Independent Urban Design Review

Proposed mixed-use development, 640 Heidelberg Road, Alphington
[PLN17/0703 (Amended)]

Prepared by Simon McPherson, for Yarra City Council

28 July 2022

Figure 17: Excerpt from current (Amended) proposal Site Plan (drawing TPO004), with my notes on proposed heights (storeys) as outlined above, in red, and my approximate indication of the lines between preferred height areas, from the Development Plan.

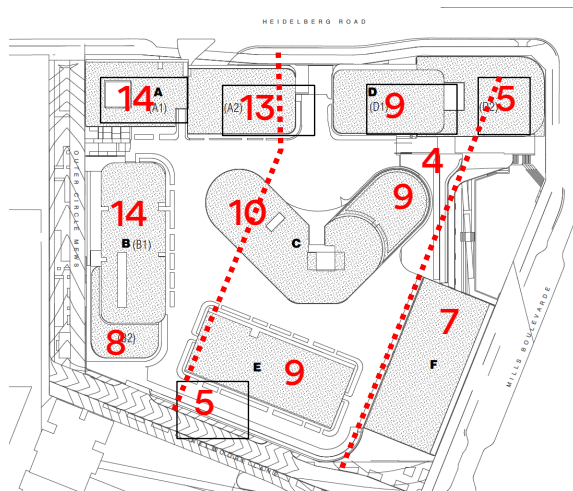
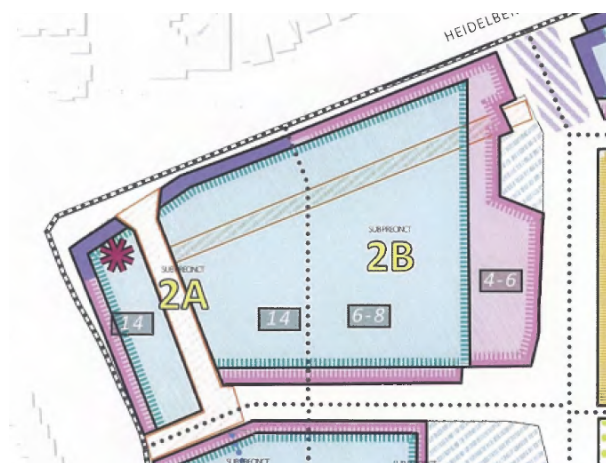
As shown above, the proposed heights are generally in accordance with the preferred heights in the Development Plan, noting the following:

Figure 20: North Elevation, current proposal, reflecting a clearer transition in heights along the Heidelberg Road frontage (except from drawing TP2000 Rev.A).

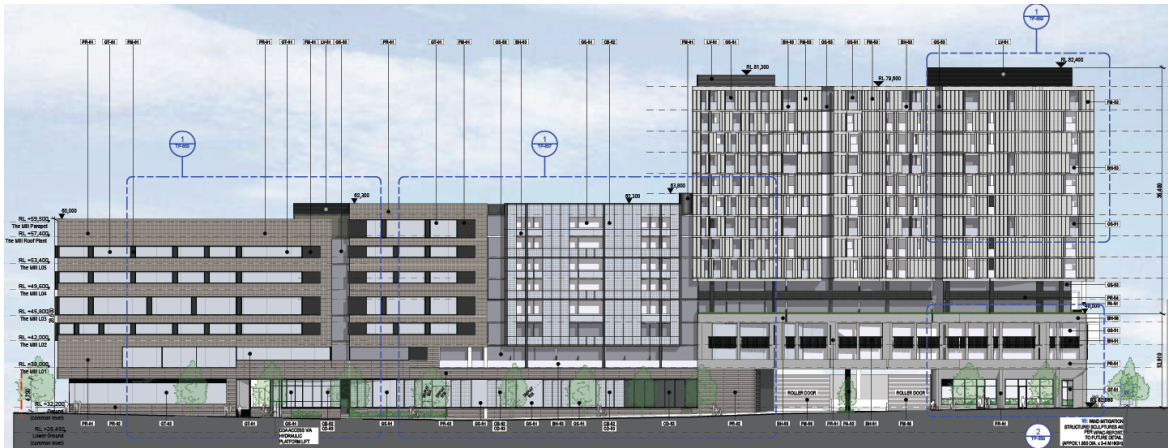
The proposed heights also provide a clearer transition in heights along Heidelberg Road, in comparison to the approved proposal, as shown below:

I therefore consider the height of Building D1 to be acceptable.

Figure 1 Multipurpose court external walls

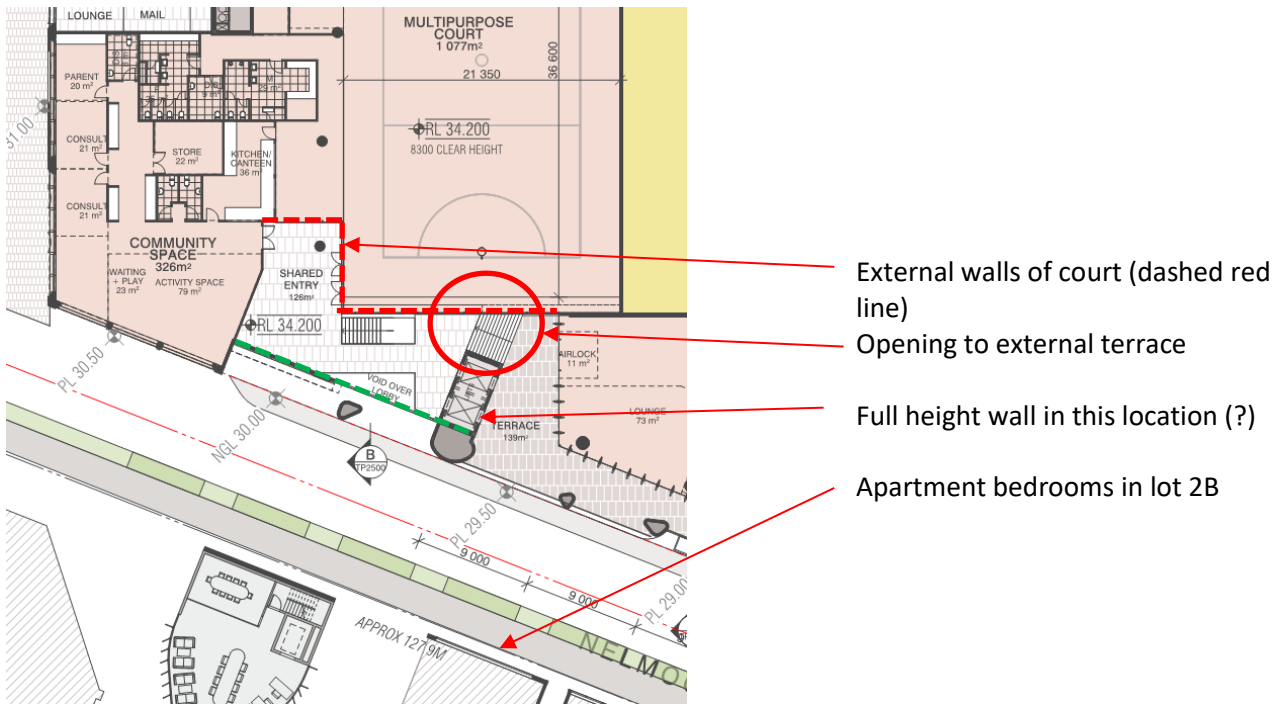
From our understanding of the architectural drawings, the shared entry to the multipurpose court is almost fully enclosed, with the only opening being the stairs to the terrace. See snip below.

We recommend that a specification be provided in the acoustic report for the external walls of the court, such that nuisance to the nearby apartments is minimised and compliance with the Noise Protocol will be achieved if the space is used for music.

Figure 1: Partial Upper Ground Plan showing new outdoor area

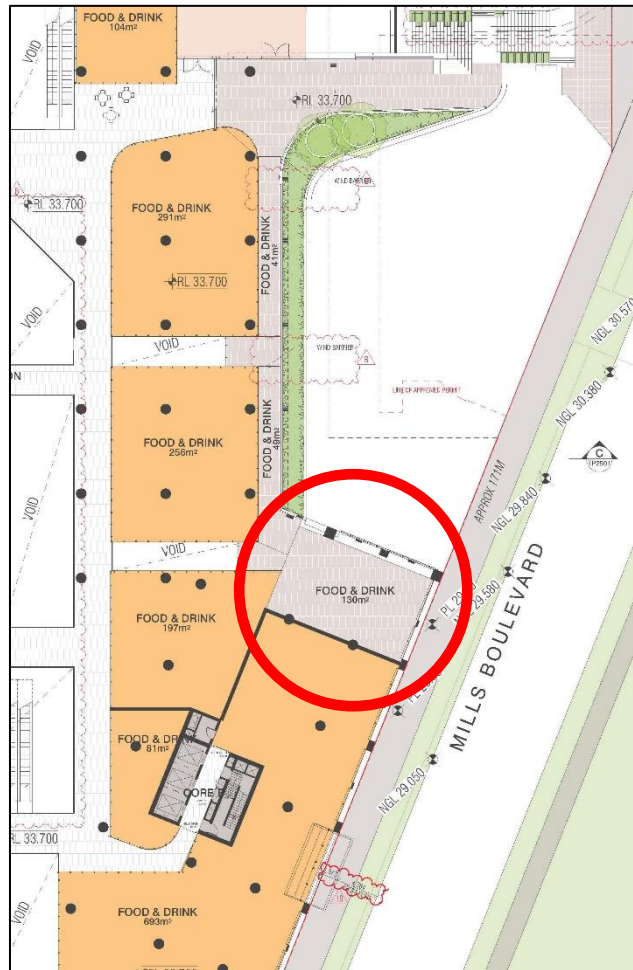
- Vipac reference drawings dated up to March 2022 but the drawings provided for the review are Revision B dated 16 June, 2022. Vipac should be provided with the latest drawings for review and confirmation that the report findings are still applicable. It has been noticed that the background used by Vipac for Figure 8 of their report is different to the Revision B drawings, particularly a new outdoor seating area that is highlighted in Figure 1. It is not clear if this is an outdoor area, but if it is it will require the assessment of the wind conditions as it is likely to be associated with the adjacent Food and Drink Tenancy for seating.

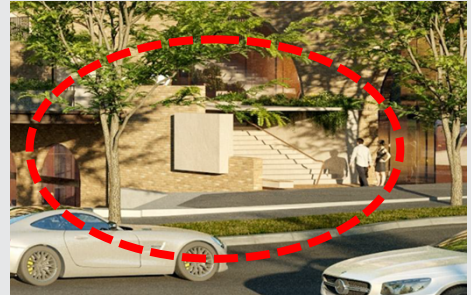
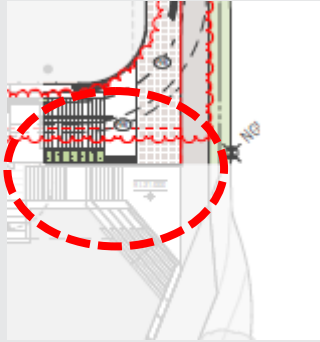
The proposed 'Grand stairway' and its interface and connection to the stairs leading to down the lower ground floor retail and F&B precinct and to Village Square is not supported in its current configuration, resulting in a poor interface/threshold where the landing is dis-connected from the other spaces facing straight onto the street with no logical visual connection.

- Modifications are requested to 're-align / angle / rotate' the 'Grand stairway' to merge it with the landing/threshold to the square creating one unified entrance threshold.

ii. *Mills Boulevard – interface booster and other services*

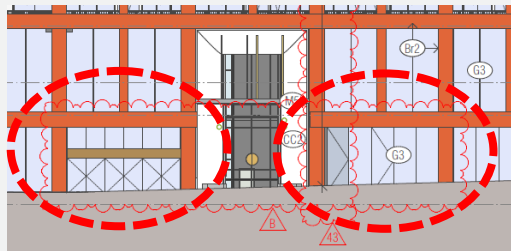
Additional details are requested to demonstrate that the full extent of the public realm interface will be perceived as an active frontage and that for example service cabinet access doors will be well integrated into the overall façade design.

iii. *Building canopy extending into Mills Blvd and Chandler Hwy*

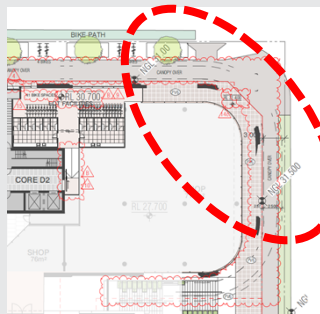
Proposed awning must be reduced in width to ensure it will not have an impact on the trees that are to be planted along the streets as per the endorsed streetscape plans.

iv. *Nelmore Lane interface*

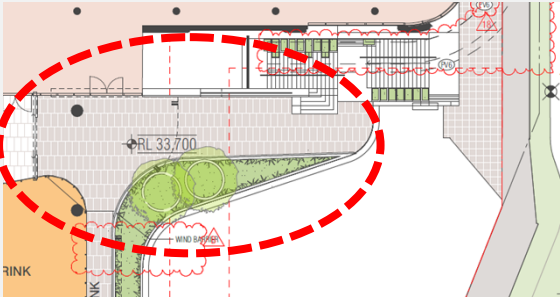
The activation of the frontage along Nelmore Lane is supported.

<ul style="list-style-type: none"> - Discrepancy between design shown on architectural compared to landscape drawings noted, complete interdisciplinary design coordination requested. - Show the design for Nelmoore Lane on all relevant plans including kerb, lighting, trees and so on. - Additional details and information are requested including but not limited to details of the proposed brick walls, seating and paving. - Litter and recycling bins must be included and shown in suitable location within the Village Precinct title boundary. - Trees to be <i>Corymbia citriodora</i> as per endorsed plans for Nelmoore Lane. Provide available soil volume for all trees and planting details.
<p>v. <i>Outer Circle Mews interface</i></p>	<p>Not satisfied</p> <p>Show the endorsed Outer Circle Mews design on all relevant plans. Noting that the endorsed plans for Outer Circle Mews show rain gardens along the interface to Village Precinct.</p>

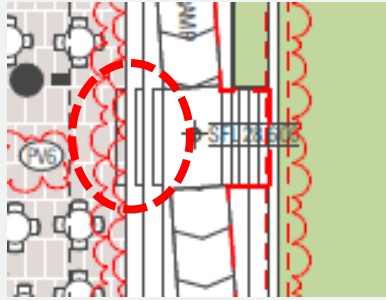
<p>iv. <i>Ramp, steps and integrated bleacher seating</i></p>	<p>Not satisfied</p> <p>The proposed ramp, bleacher / seating configuration wrapping around the square is not supported in its current configuration, refer point above regarding the ramp alignment and notes below.</p> <ul style="list-style-type: none"> - Detailed 3D views are to be provided to fully demonstrate that all aspects have been carefully considered including but not limited to functionality/useability, any required elements such as raised edges, handrails, tactiles and drainage. - Design modifications are requested including but not limited to reconfigure the stairs resulting in a step

protruding into the pedestrian access around the square, see area highlighted below.

vi. *Podium trees impact on square*

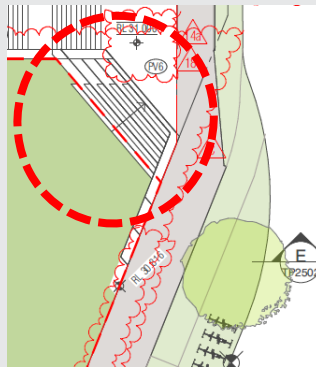
Review podium tree species to ensure maximum winter sun to the square below is provided.

viii. *Interface to retail precinct*

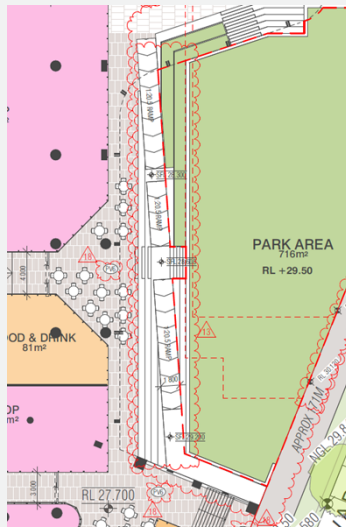
It is requested that a minimum 1.8m clear pedestrian access path is accommodated for along the perimeter of the park (outside the park boundary), (1500mm path access and a minimum 300mm width to allow person to sit on the edge causing minimal obstruction to the path).

ix. *Scale and connection to levels above*

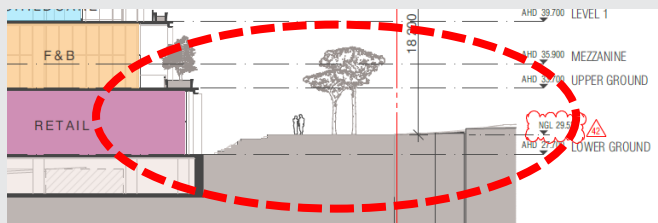
Additional detailed sections are required through the proposed building / square / road. Describing all proposed different interface typologies.

x. *Ground floor safety and access*

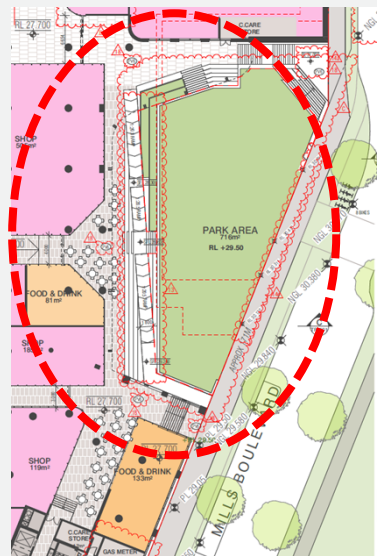
Concern that the different setbacks of doors and openings (along the west interface to the Square), the overshadowing/reduced access to natural light and the times when shops and other premises are closed will result in an uninviting, unsafe environment with high risk for loitering and anti-social behaviour.

- It is requested that the full interface to Village Square is reviewed on those aspects to create a safe and inviting environment that will not rely on activation from shops or other tenancies to be a safe space.

i. *Proposed paving materials general*

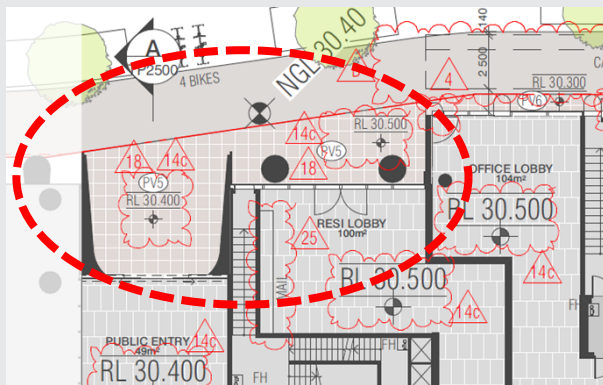
Discrepancies between landscape and architectural. It is requested that a detailed paving plan is provided showing clear areas of the proposed different paving types.

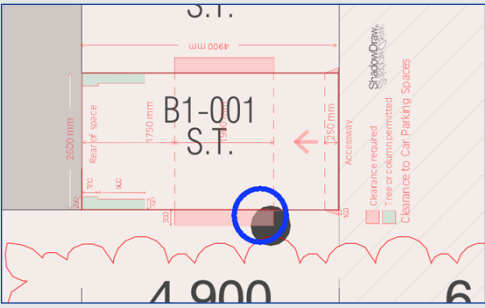
Item	Assessment
Access Arrangements	
Development Entrance – Heidelberg Road	Not dimensioned on the drawings.
Visibility – Heidelberg Road	Pedestrian sight triangles have not been superimposed on the drawings.
Basement Entry – Nelmoore Lane	<p>The 3.0 metre widths of the two exit lanes satisfy AS/NZS 2890.1:2004. However, the entry lane width requires an additional 300 mm as it immediately abuts a wall, as shown below:</p> 
Visibility – Nelmoore Lane	<p>Visibility for the easternmost exit lane onto Nelmoore Lane is obstructed, as shown below:</p>

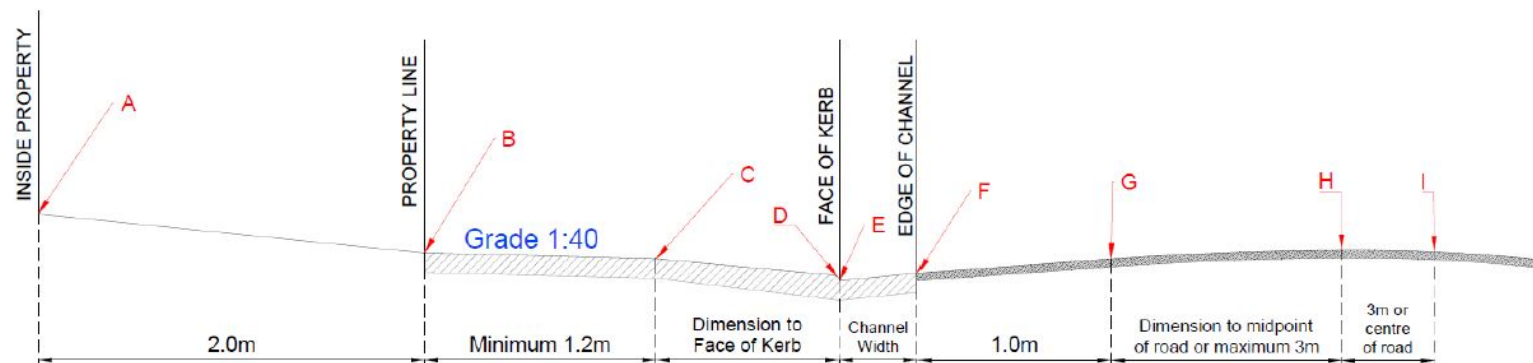
- Please note the cross section must be fully dimensioned. As shown in the sketch below.
- Please show both the existing and proposed surface.
- The maximum allowable cross-fall between points B and C is 1:40 (2.5%).
- A bullnose (max 60mm) is permitted at point D, however not compulsory.
- The levels shown must be exact reduced levels, to three decimal points. Interpolation of levels is not acceptable.
- The designer must demonstrate that an 85th or 99th percentile vehicle profile can traverse the design cross section as per the Australian/New Zealand Standard ground clearance template (AS/NZS 2890.1:2004).
- Significant level changes to the existing footpath level B to C will require additional level design either side of the proposed crossing.
- Please include any additional levels or changes in grade that are not shown in the diagram.

Figure 1 - Heidelberg Rd levels at the interface

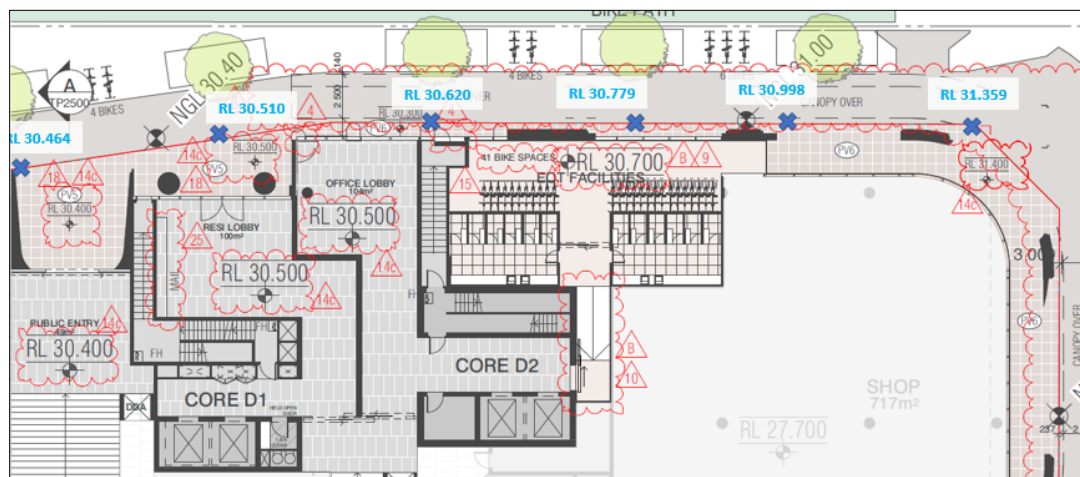
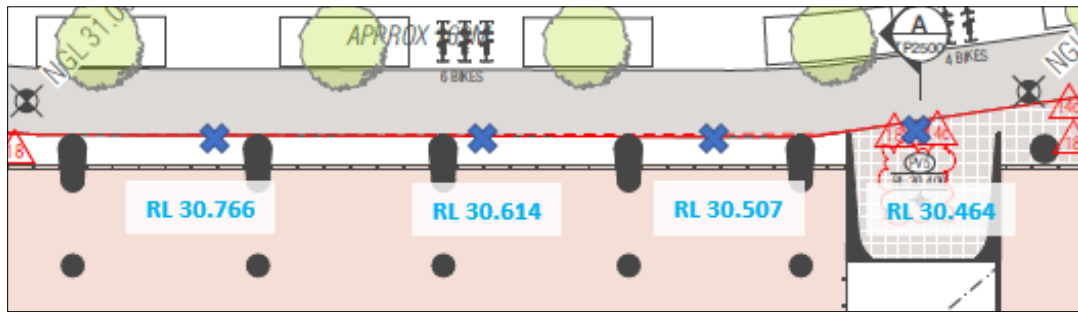
There are slight differences between the proposed FFL's internally and the proposed Heidelberg Rd levels at the interface, particularly at the entrance points – see Figure 1 below. The internal FFL's must be adjusted to align with the levels at the interface with Heidelberg Rd road reserve.

If the levels at the boundary are to be different to the Heidelberg Rd levels, provide reasoning and justification i.e. retaining wall, steps, etc.

Figure 2 - Mills Blvd interface level differences

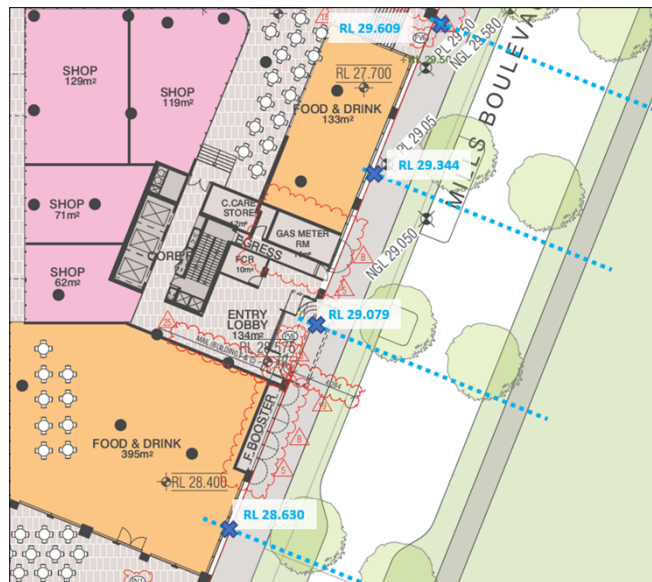
If the levels at the boundary are to be different to the Mills Blvd levels, provide reasoning and justification i.e. retaining wall, steps, etc.
